RE: Highland High School Title IX Gymnasium Upgrade-Phase 1
4700 Coal Ave SE
Requested Permanent C. O. – Not Accepted
Engineers Stamp Date 6/23/16 (K17D021)
Certification dated: 10-16-18

Based on the certification provided in your submittal received 10/16/2018, the above referenced is disapproved for a Permanent Release of Occupancy by Hydrology. Before a permanent CO can be accepted the following comments must be addressed.

Re: Highland HS Title IX Gym Upgrade – Hydrology Permanent CO
COA Hydrology #K17D021A
Building Permit # 2018-11701 – Phase 1

A1 GRADING PLAN
SCALE: 1" = 20'

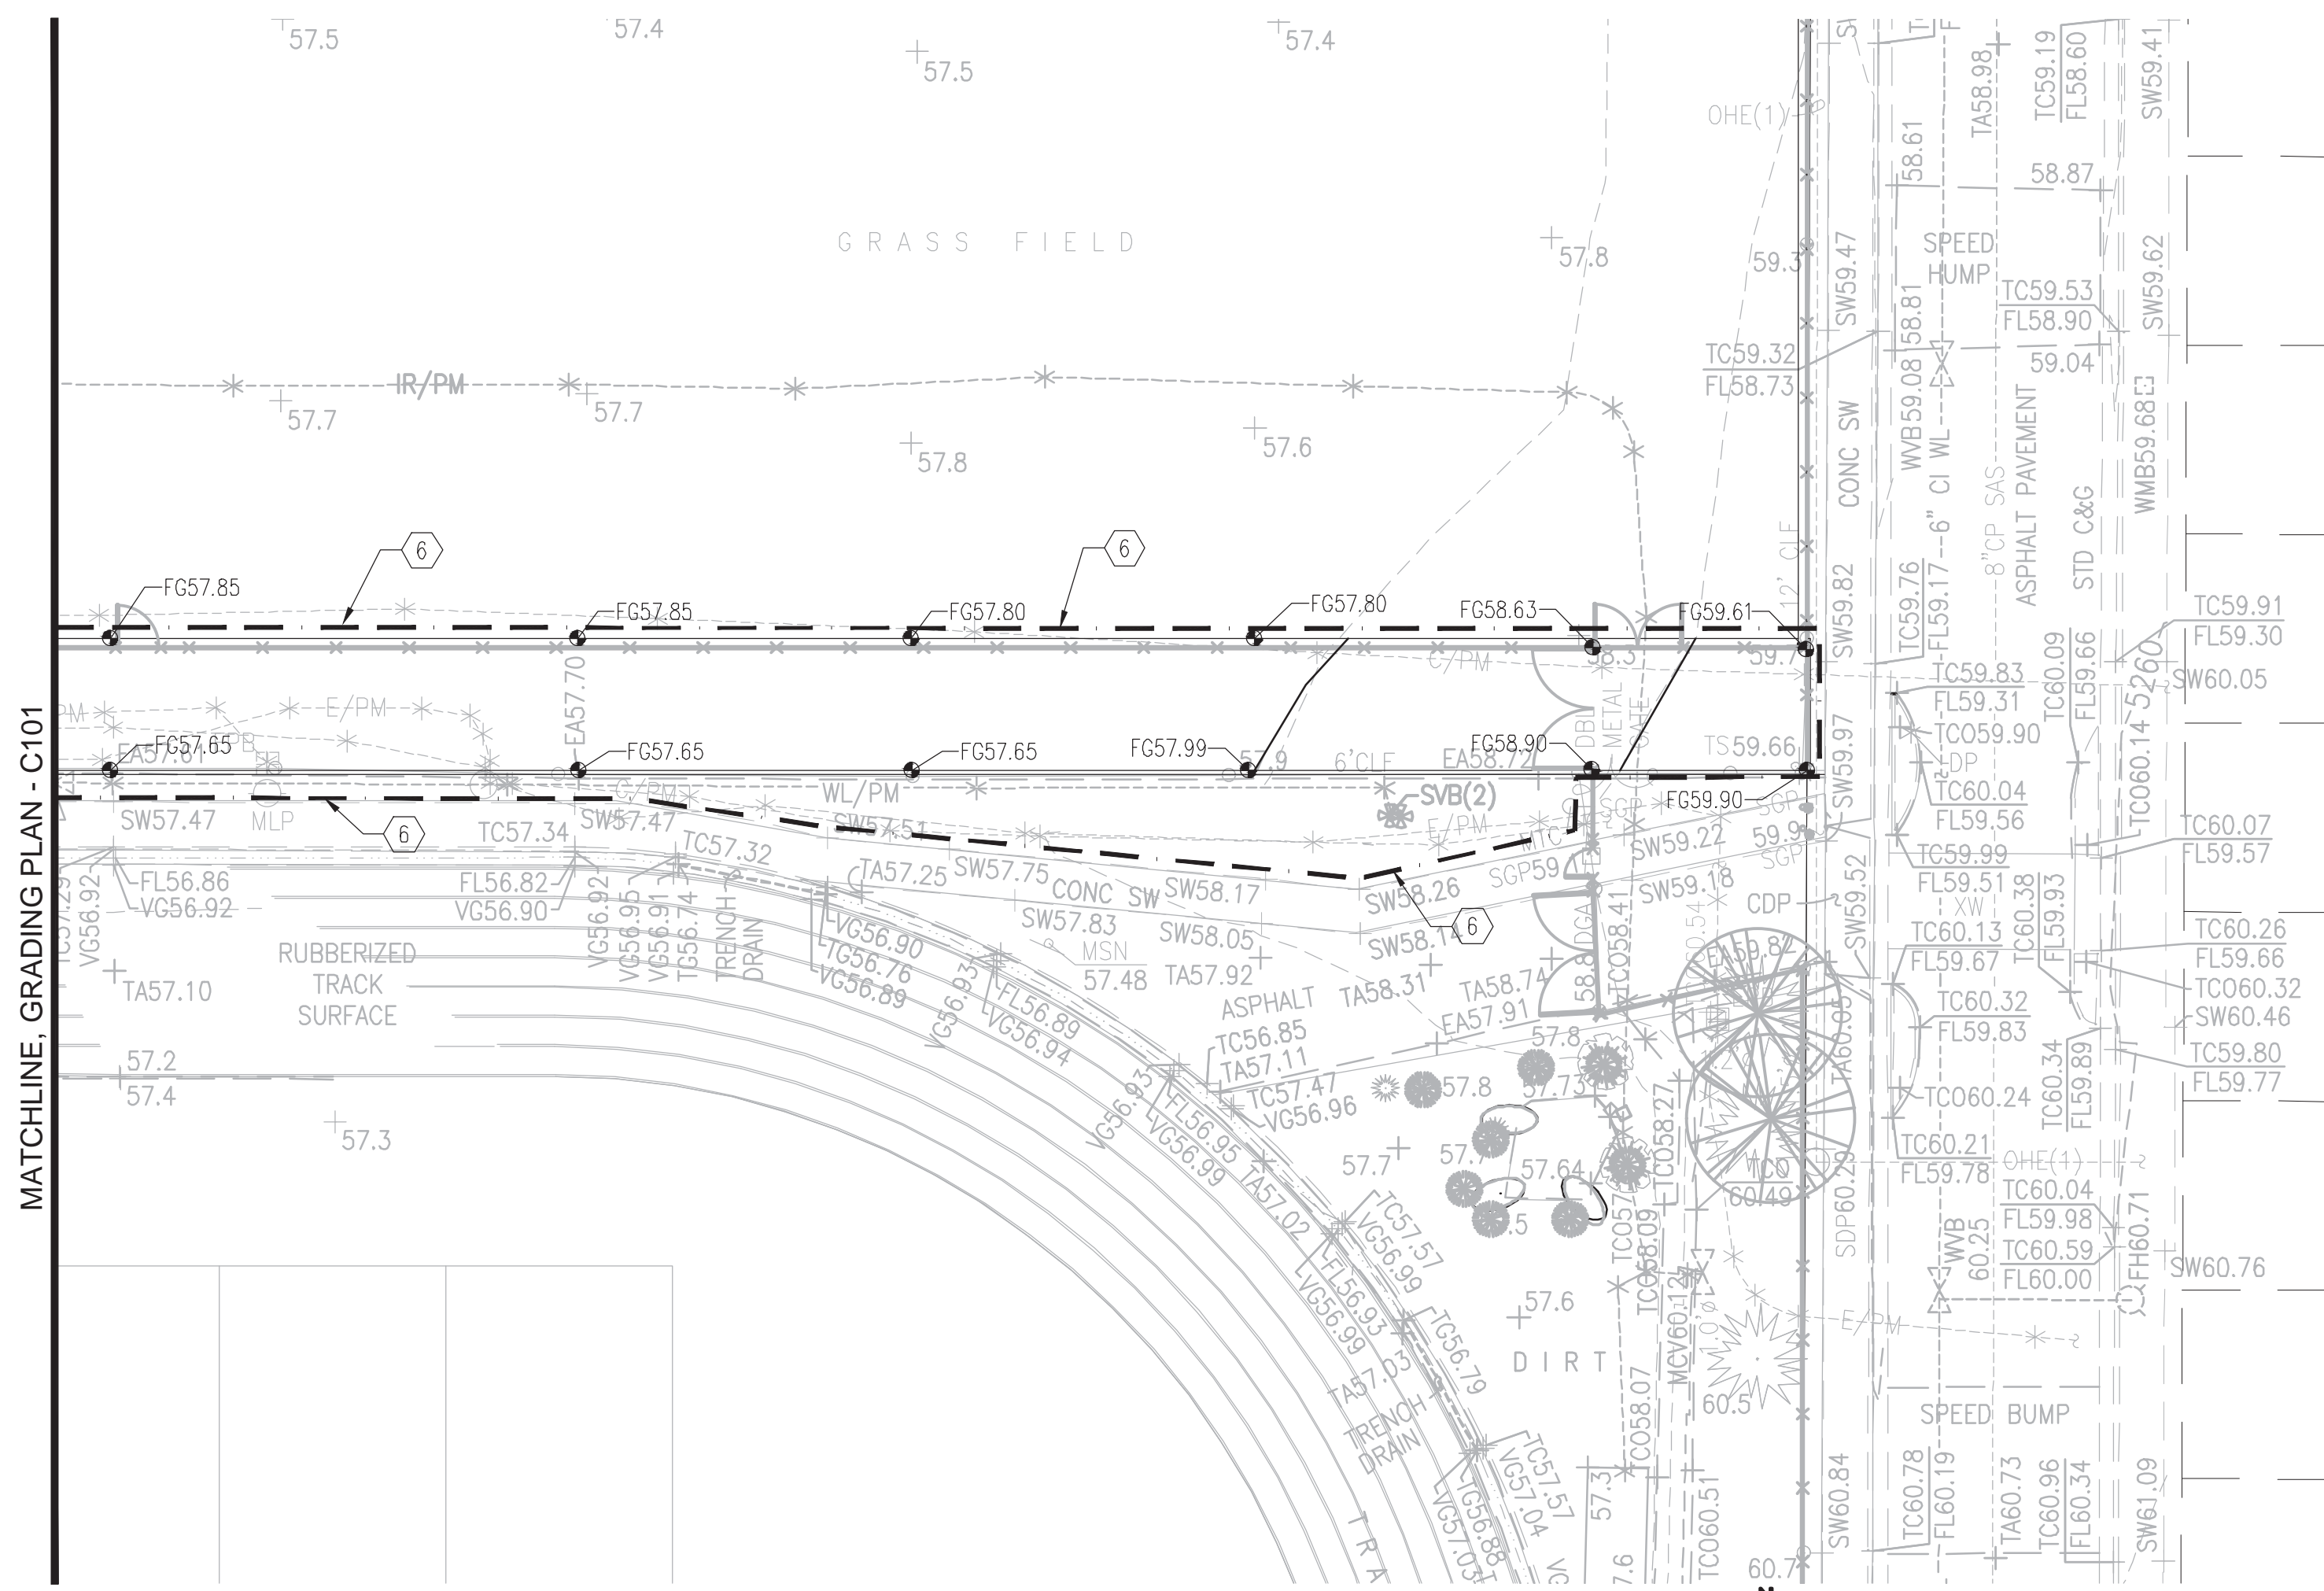
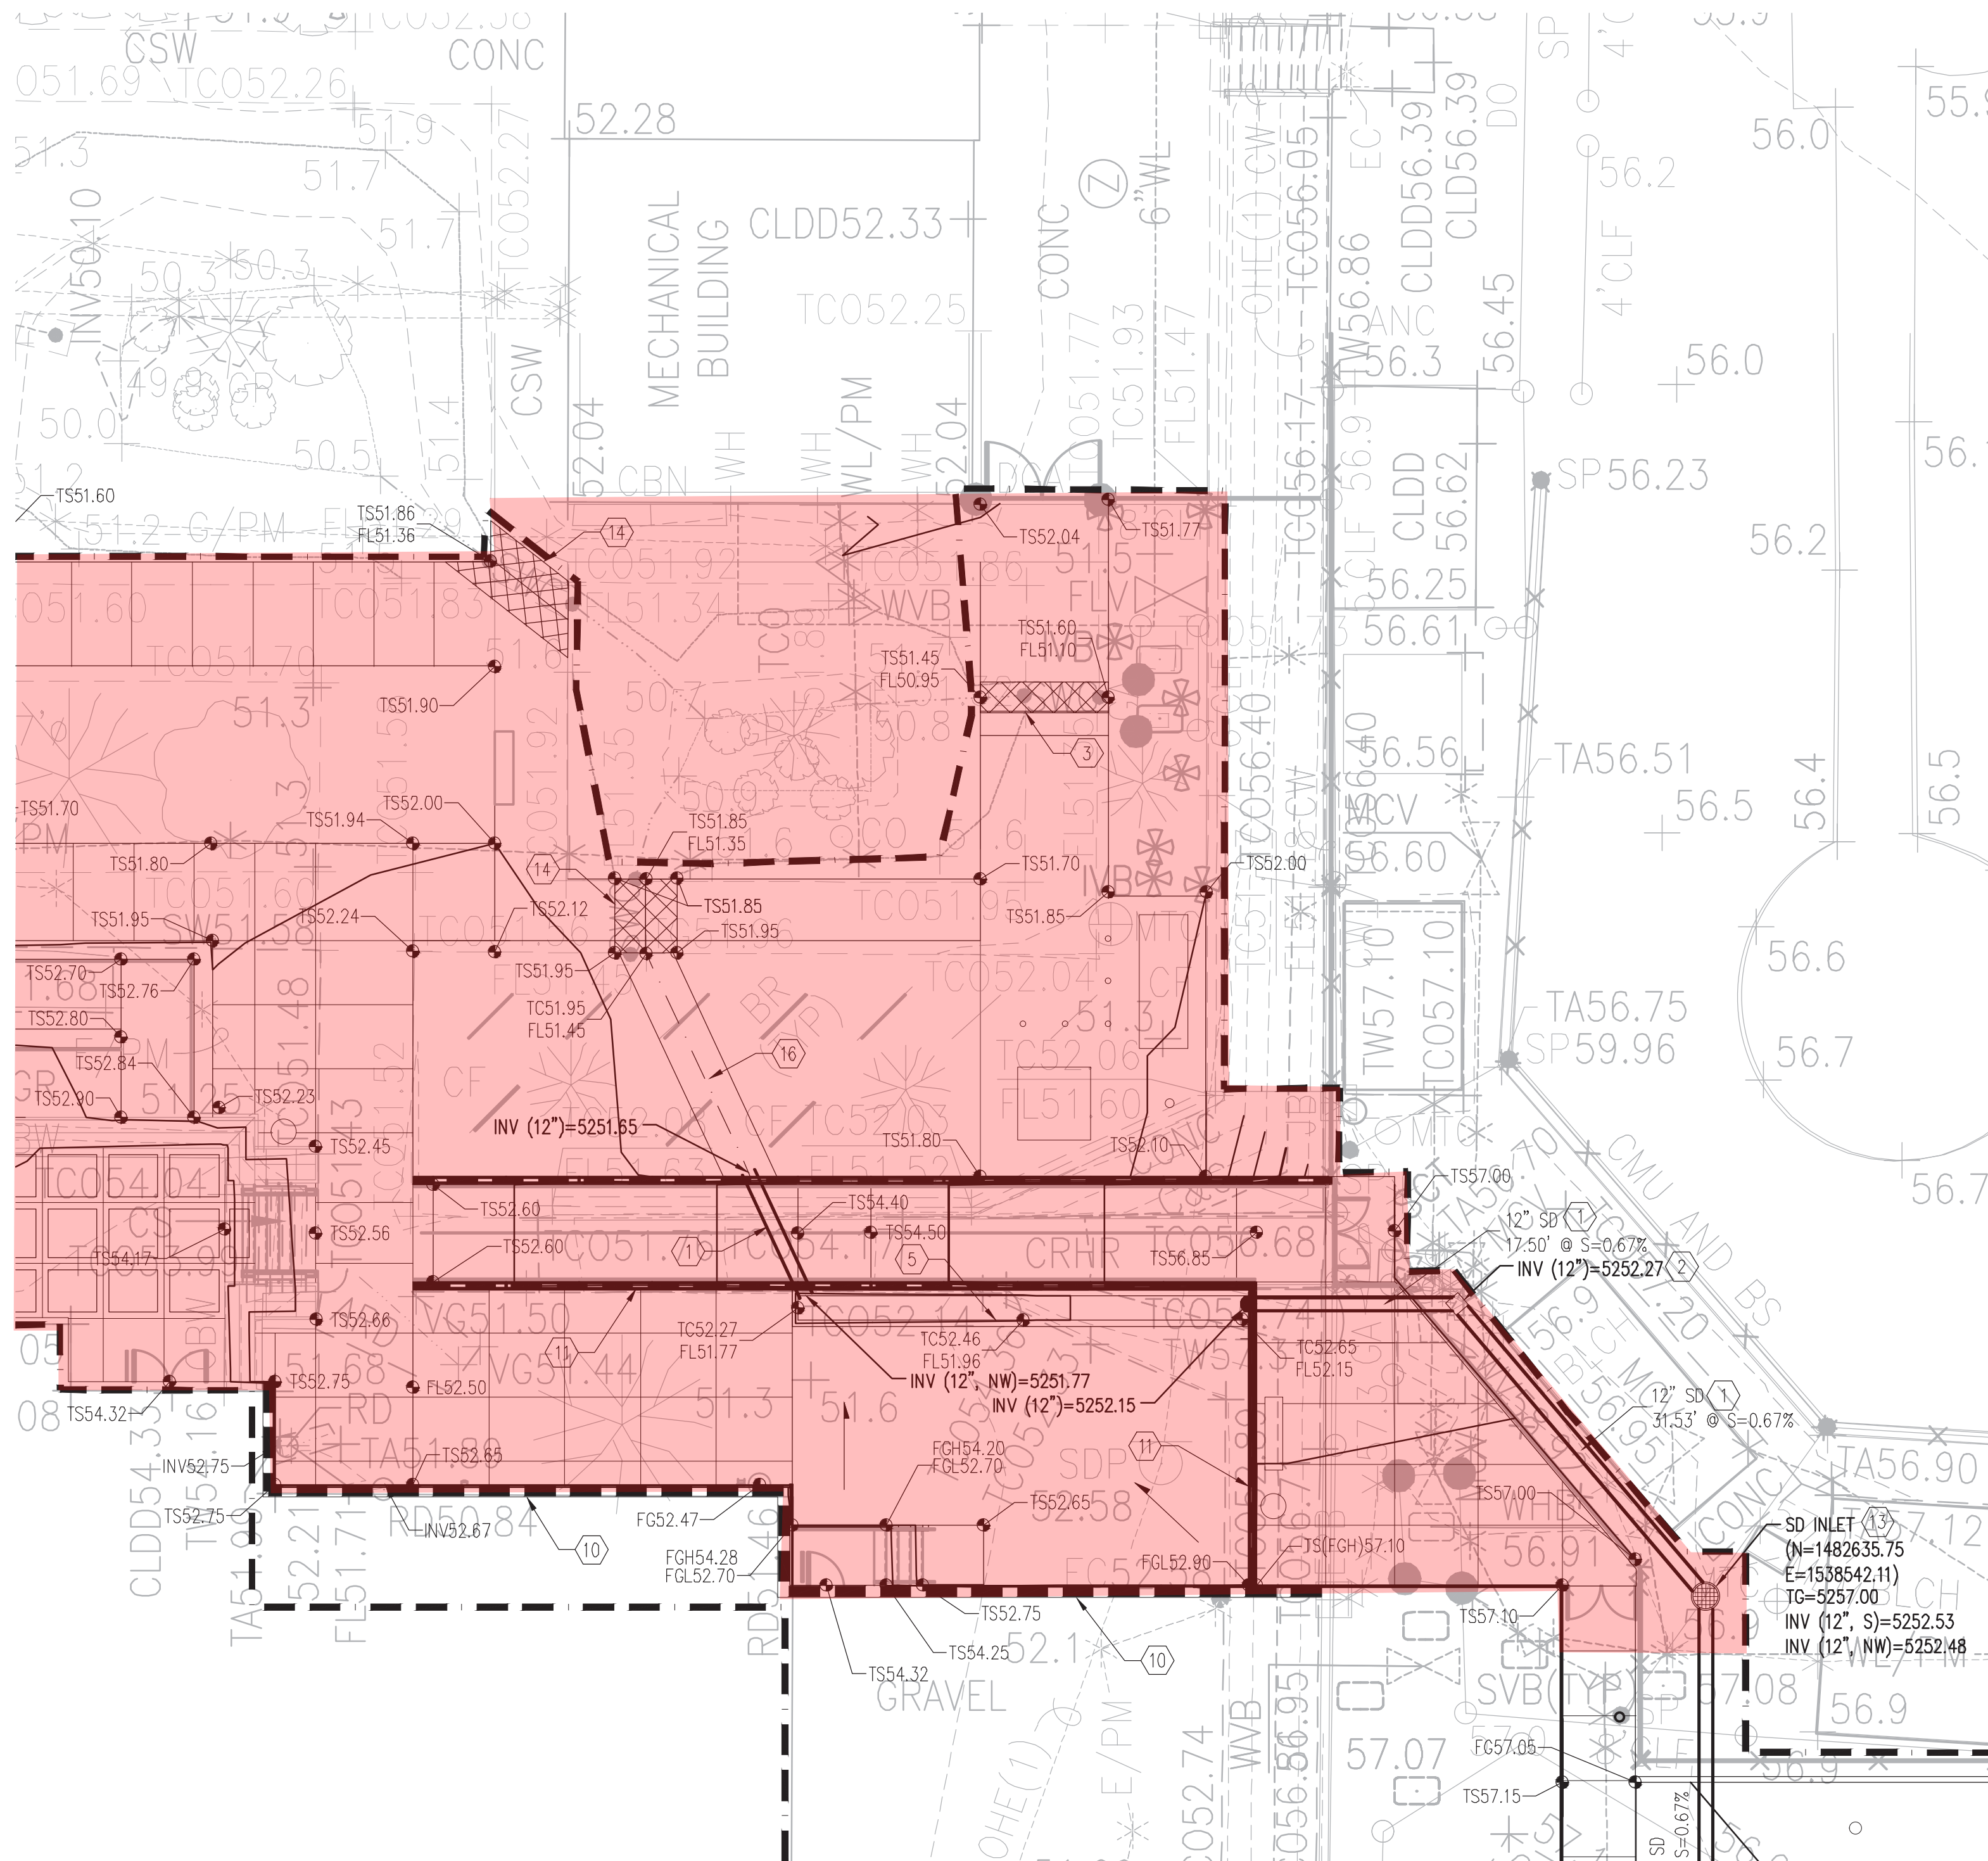
- All construction fencing is to be removed from Phase 1. See attached pic.
- The further most north double Sidewalk Culvert is incomplete. See attached pic.
- The Hydrology certification must be on the drawing, not a separate letter.

1. 4' Wide Valley Gutter not installed at correct angle per plan. Sidewalk Culverts will need to be removed and placed in the correct location per plan as a result.
2. Landscaping not completed at the time of the site visit.
